Omaha Public Power District
1623 Harney Omaha, Nebraska 68102
402/536-4000

September 28, 1984
LIC-84-323

Evaluation of Inadequate Core Cooling Instrumentation System
for the Fort Calhoun Station Unit No. 1

Attachment 1

FIGURE 1

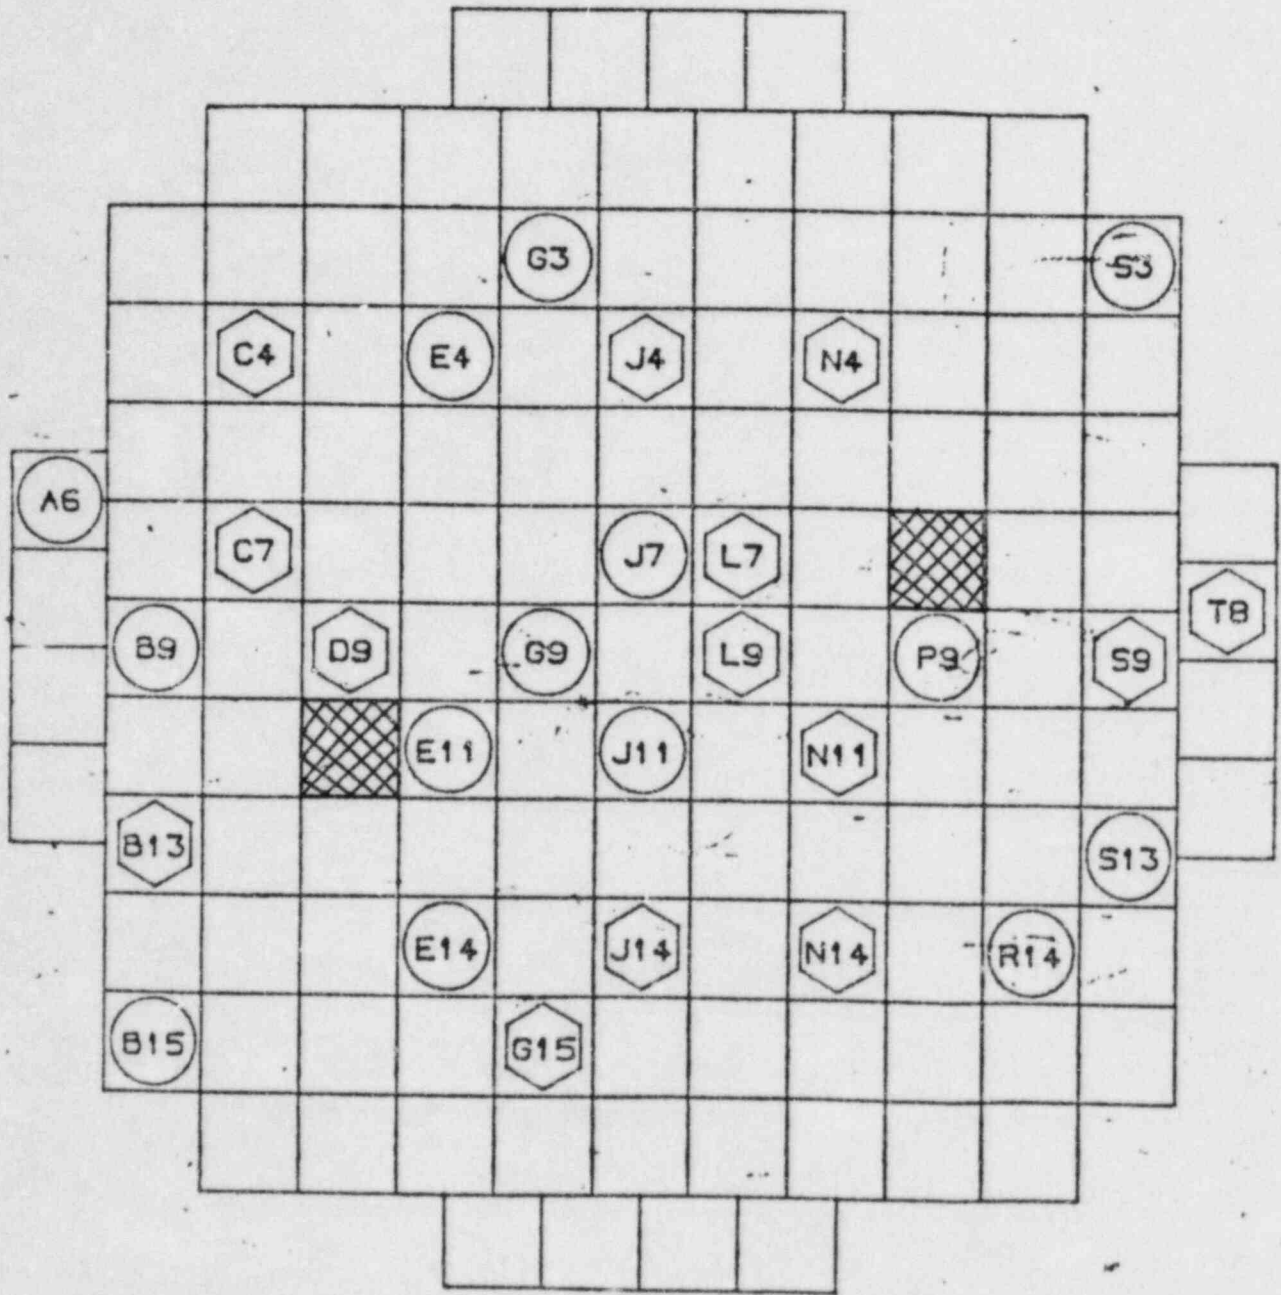
- 1) Describe the status of the RVLMS installation including a schedule for completion of installation and calibration and provide a sketch to show the locations of those thermocouple sensors relative to the reactor size.

The installation of the RVLMS is essentially complete. Reactor head modifications, heated junction thermocouple (HJTC) probes installation, in-containment mineral-insulated (MI) cable installation, and Qualified Safety Parameter Display System (QSPDS) installation have been accomplished. The RVLMS is currently undergoing an Operational Availability Demonstration Test and will be left running throughout the remainder of this operating cycle. This is to prove reliability and to allow personnel to gather experience with the system. Since plant startup from a refueling outage in July, 1984, the system has shown excellent reliability. Providing this performance continues, the system will officially be declared operable after the end of the next refueling outage, currently scheduled to begin in December, 1985 (reference Attachment 2 for detailed schedule). A core map showing relative Core Exit Thermocouples (CET's) and HJTC locations is attached, (see Figure 1).
